Planning Board AGENDA

Re: Revised Site Plan Review comments- 404 Silver Street Agawam, MA 01001;

**Re: Battery Energy Storage System (BESS), 404 Silver Street, Agawam MA
Response to Comments – Site Plan Review Application**

Proposed Hotel

GRADING AND EROSION CONTROL PLAN

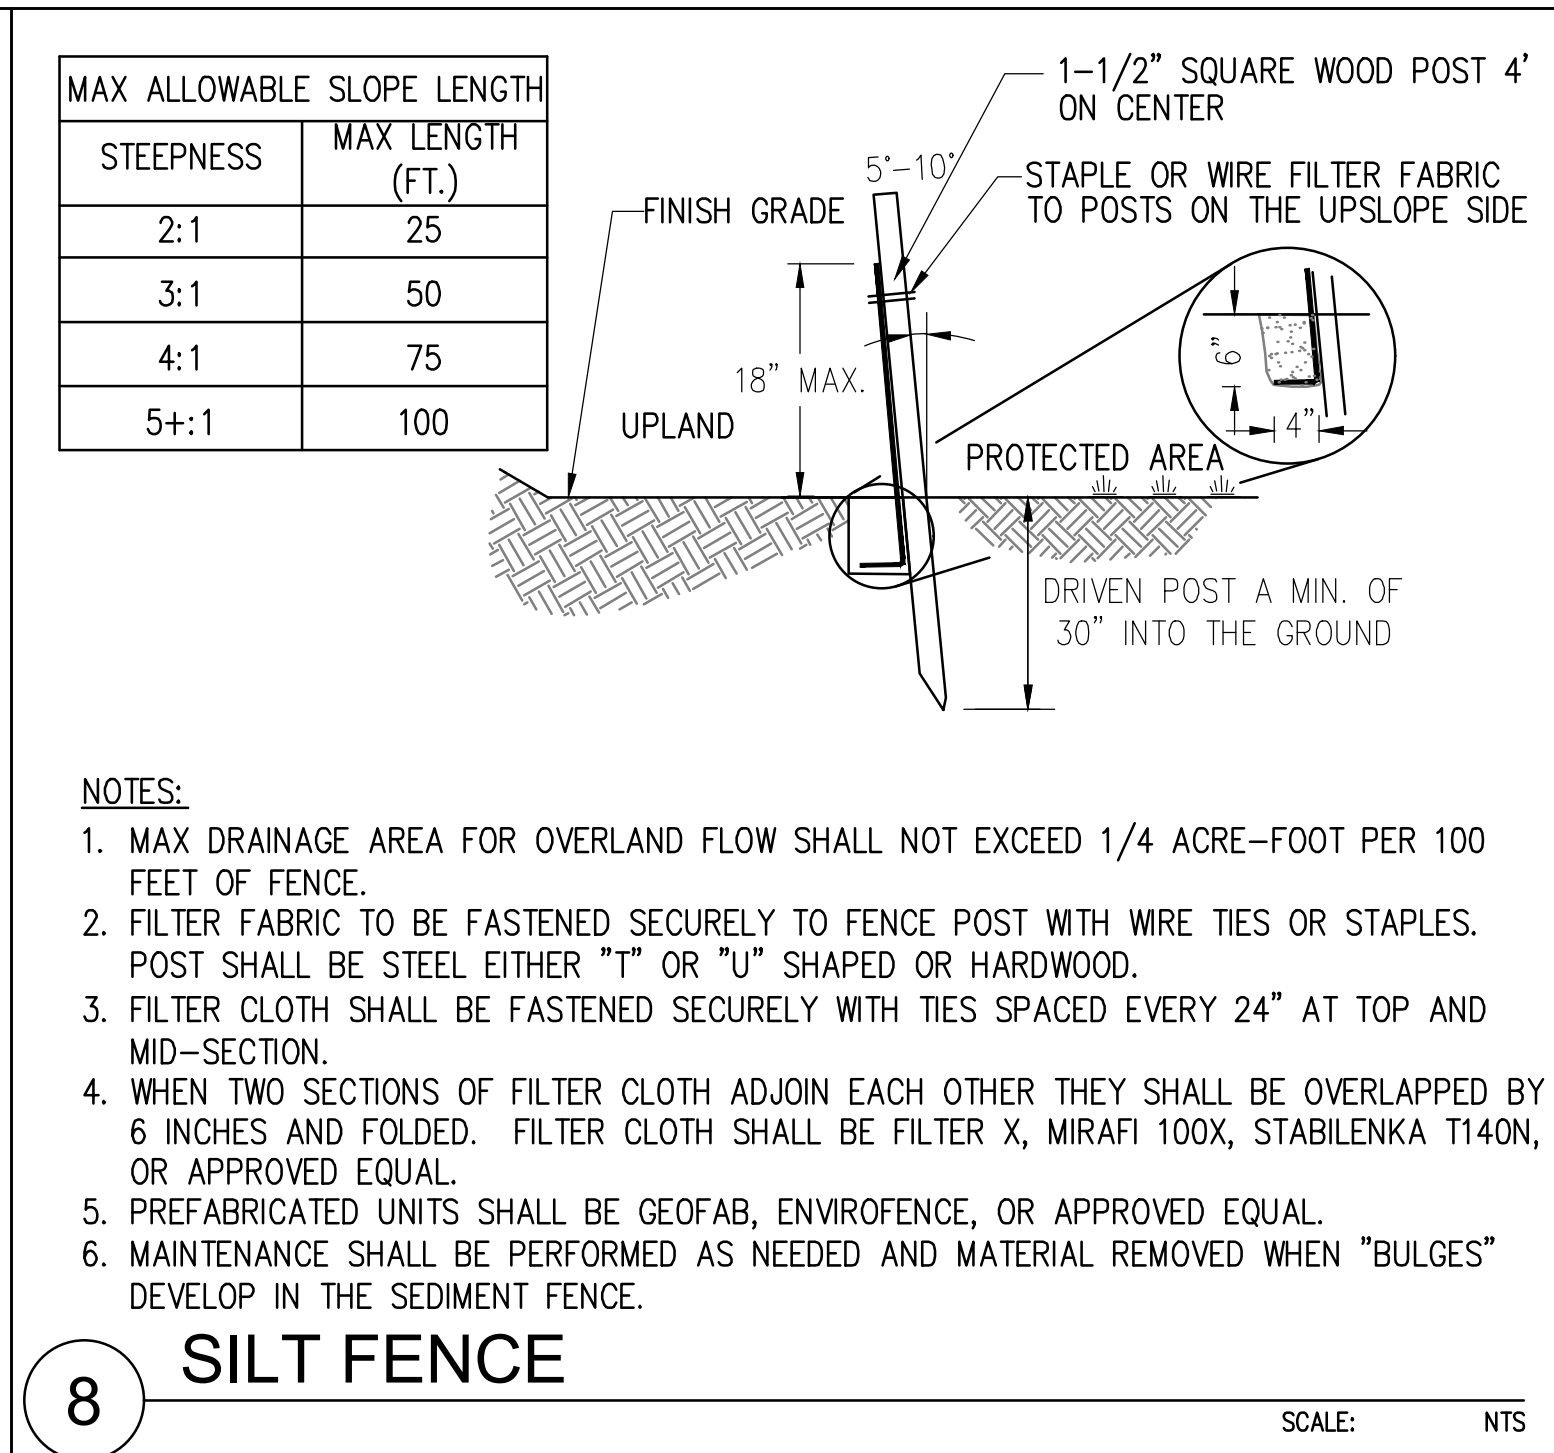
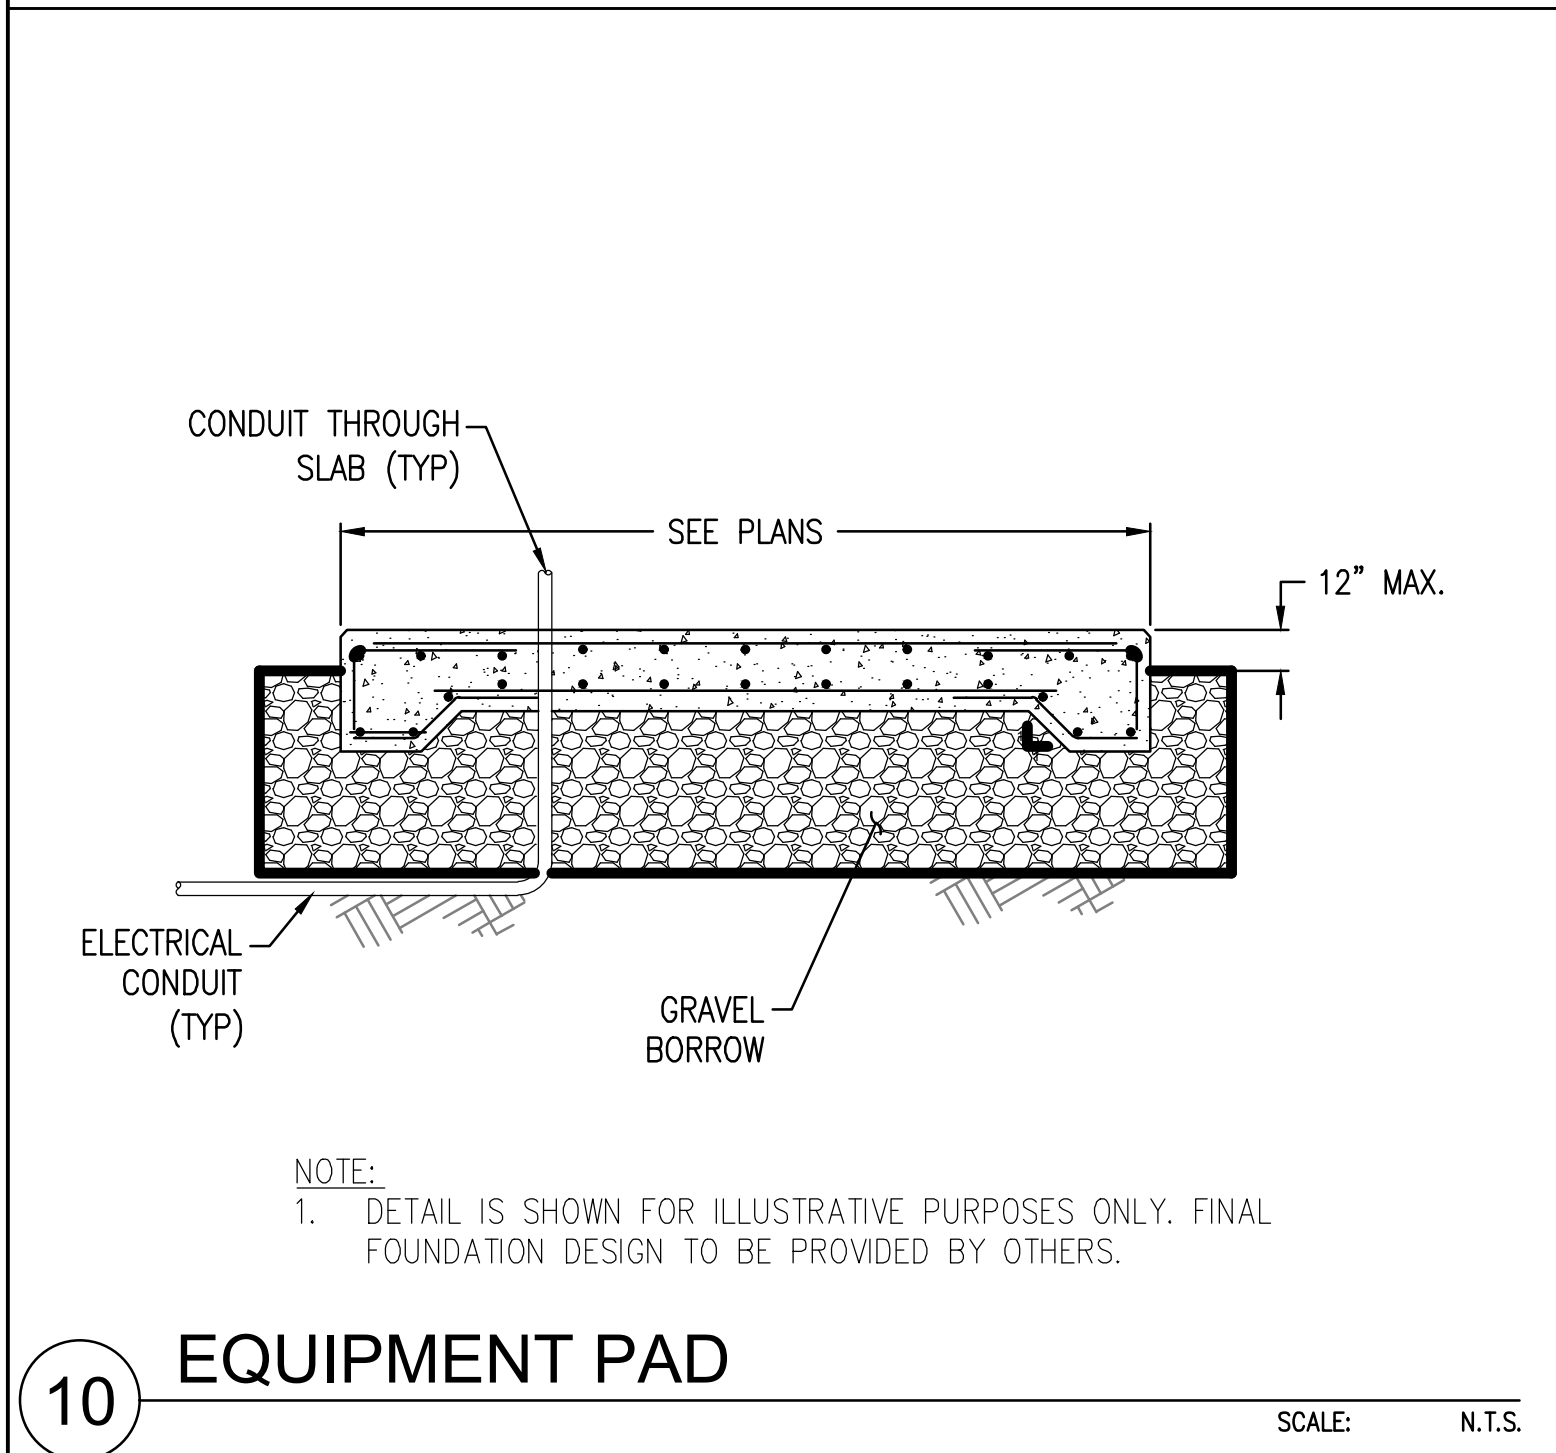
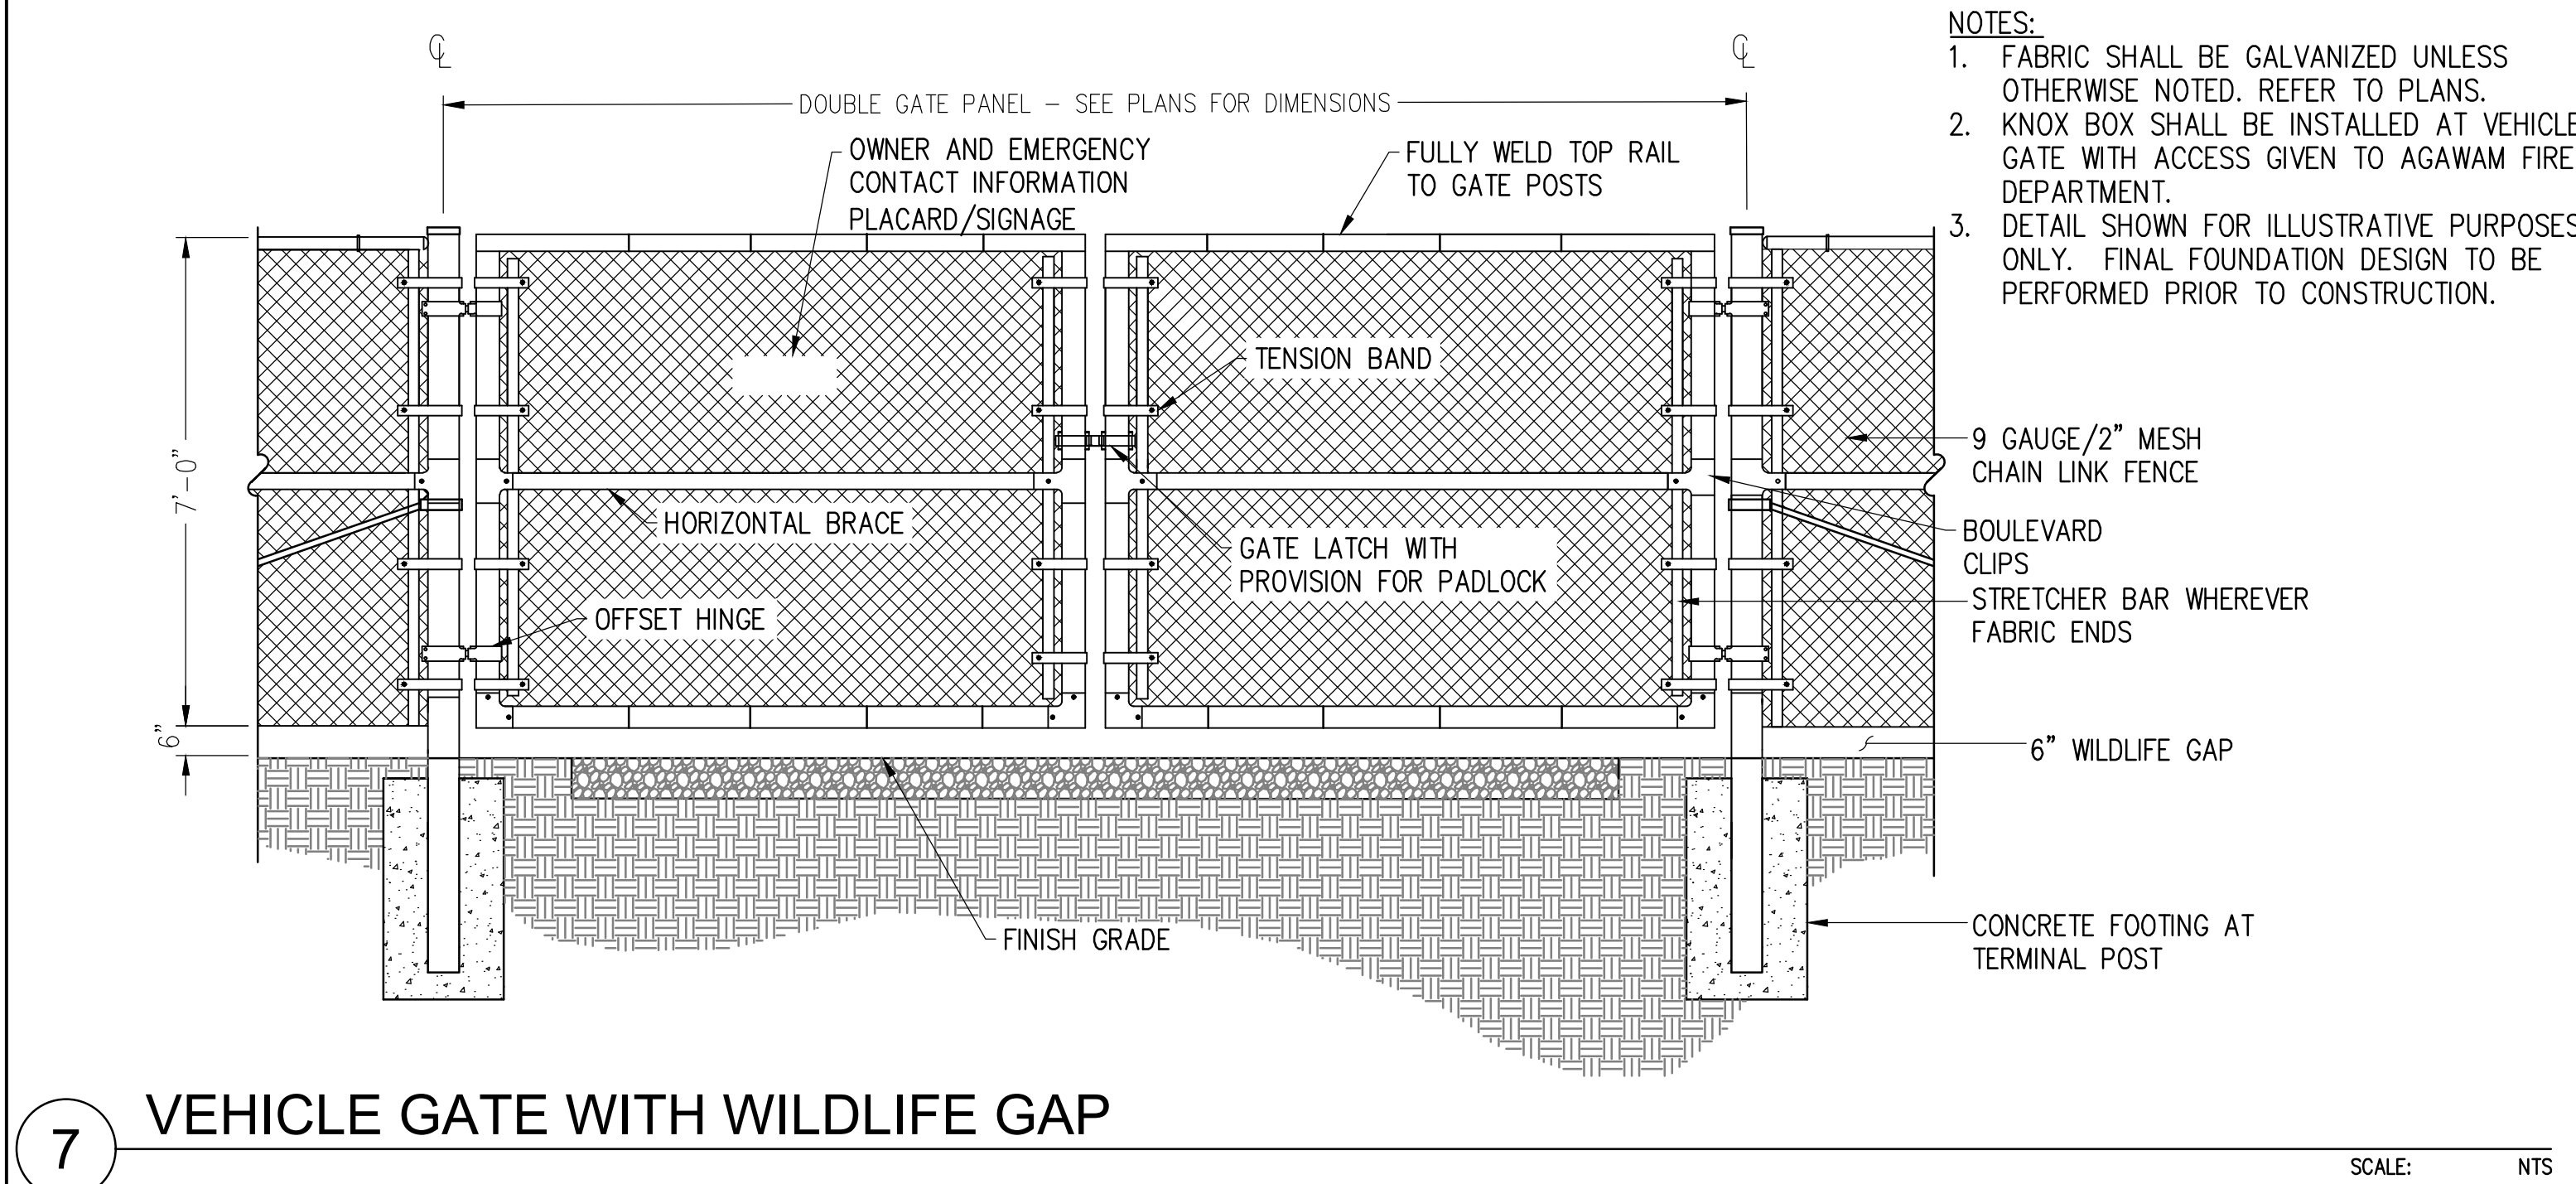
- 2. The plan calls for a silt fence to be installed on the east side of the driveway only at the very end of said driveway. Please extend the silt fence along the limit of work for the entire east side of the driveway.**

- 4. Sheet C-4.0 of the plans has a leader pointing to a riprap swale but it is unclear how that swale is graded and the extents of its location.**

The Grading and Erosion Control Plan (Sheet C-4.0), included in Attachment A, illustrates the revised silt fence location, extending along the limit of work for the entire east side of the driveway.

The riprap swale has been removed from the project plans and replaced with a stone infiltration trench as shown on the Grading and Erosion Control Plan (Sheet C-4.0) included in Attachment A.

C-4.0
GRADING AND EROSION CONTROL PLAN

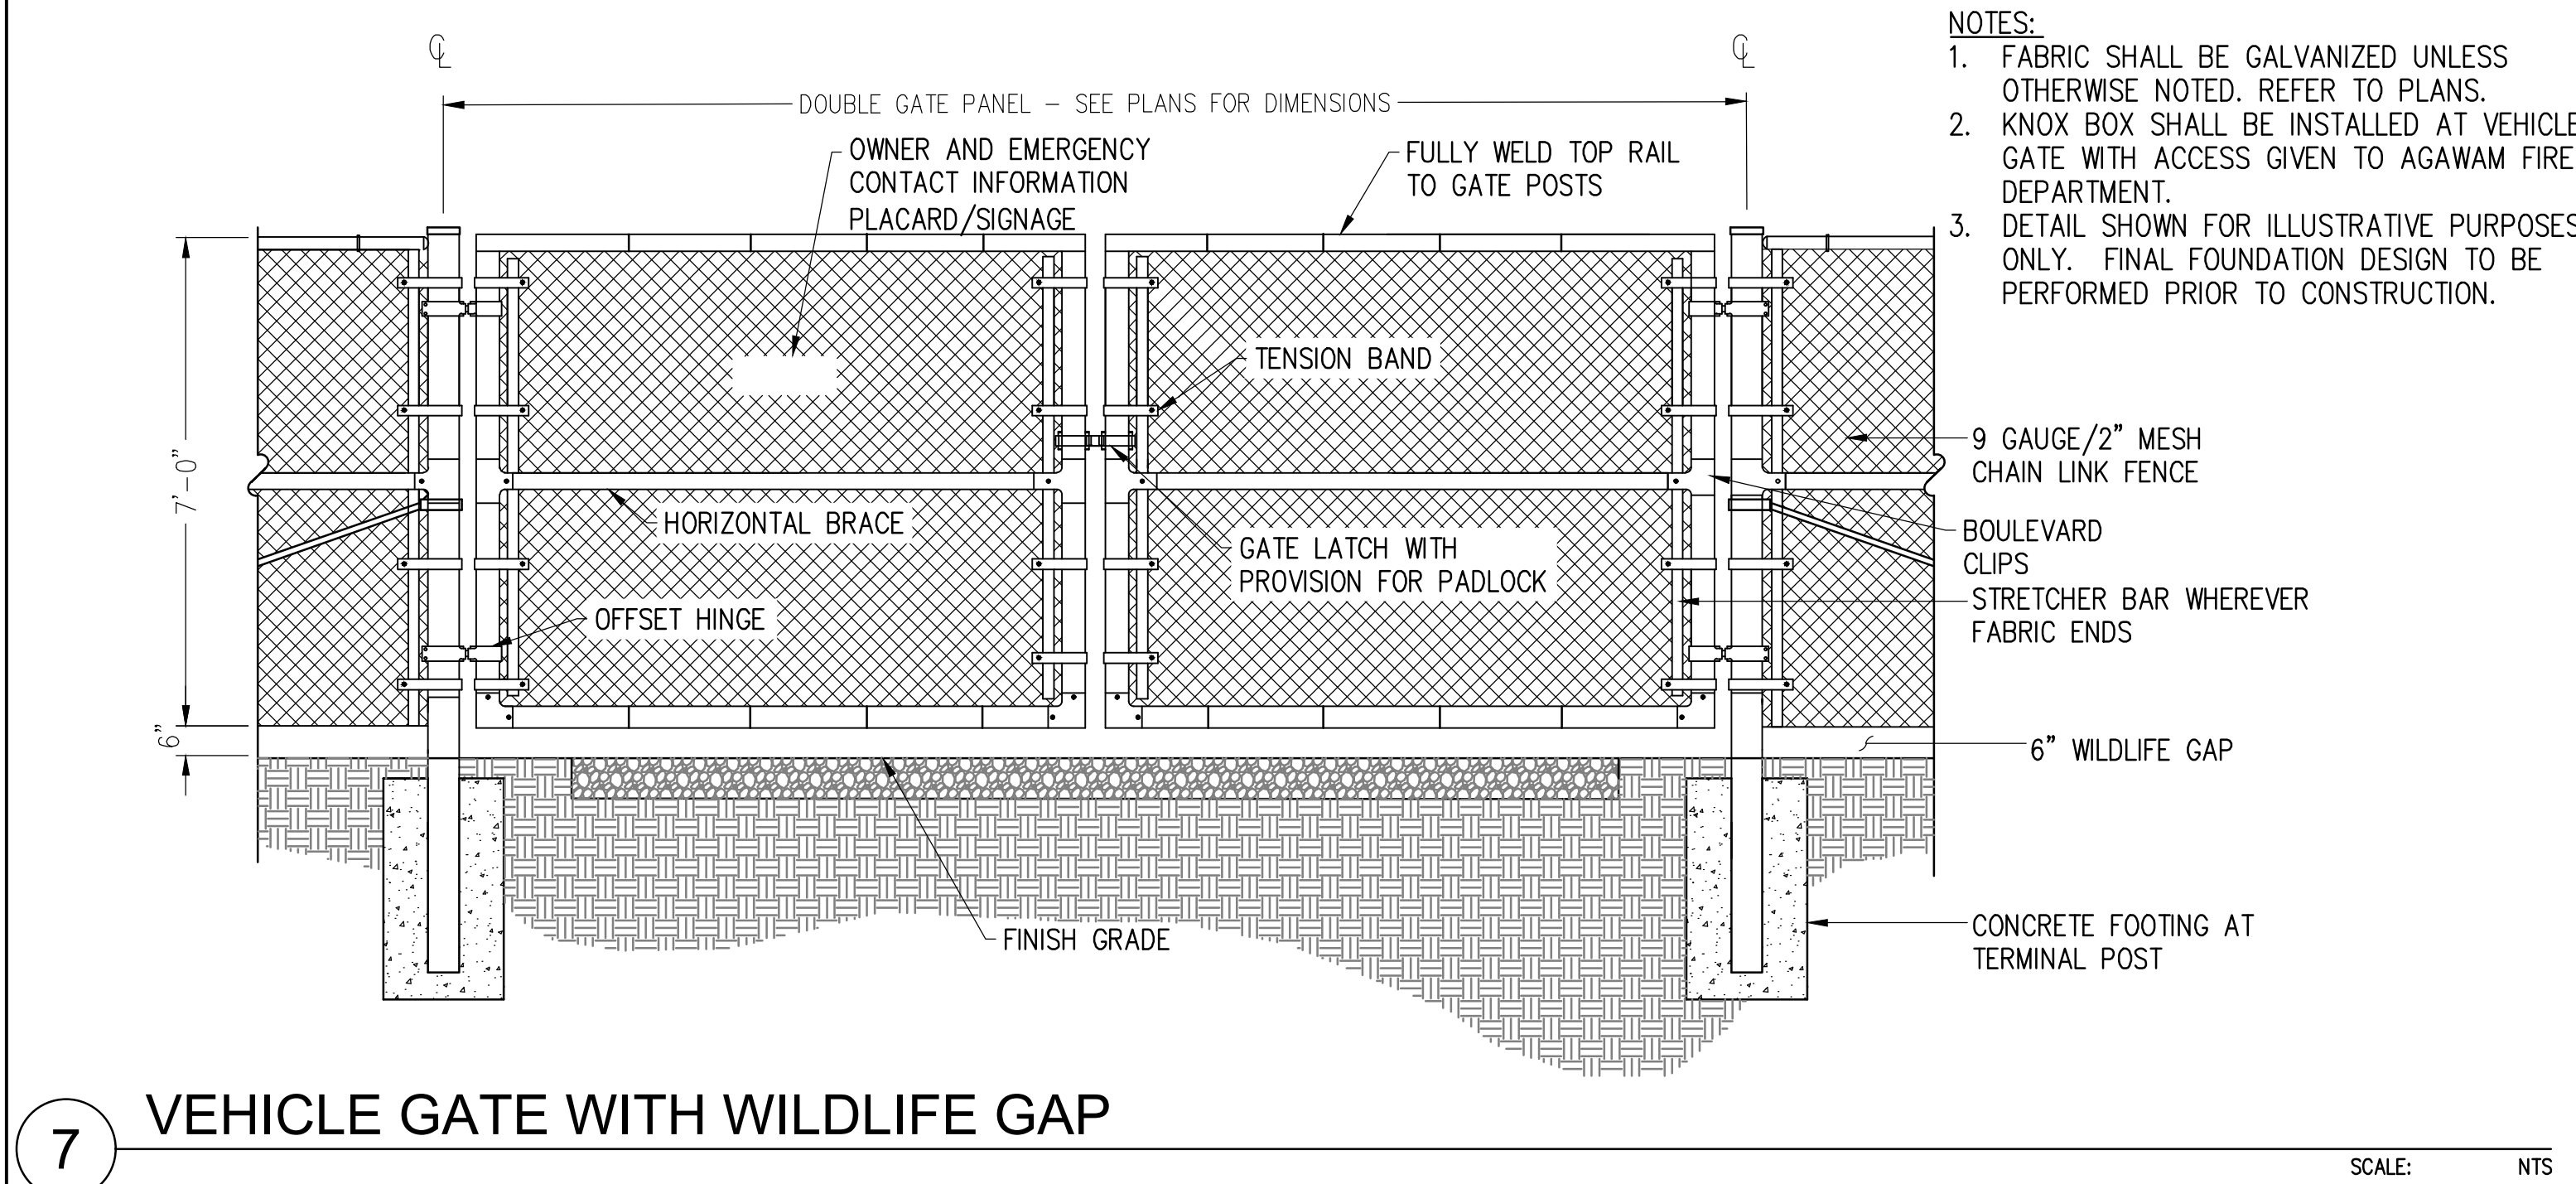
- 3. The catch basin on Silver Street needs inlet protection from any excess sediment as a result of this project. The Grading and Erosion Control Plan (Sheet C-4.0) and the Civil Details (Sheet C-5.1), included in Attachment A, include silt sack protection for the catch basin on Silver Street.**
